Access Compliance Report
Public Rights-of-Way
(Curb Ramps)

Main Street: VAN_BUREN_ST **Cross Street:** MADISON_AVE **Location:** SW

ADA ID: RPRK211001195220 **Ramp Type:** Type 1 - Perpendicular Diagonal **Initial Pass/Fail:** Fail **Overall Compliance:** No **Severity Score:** 35

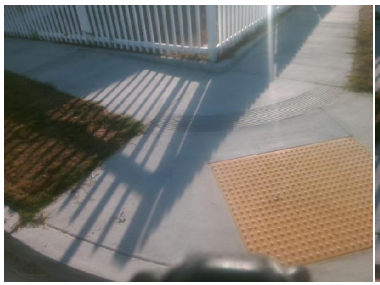
R304.2.2, R304.5.1, R304.5.3, STD 1115

Remove & Replace Curb Ramp With Two New Directional Ramps or Equivalent.
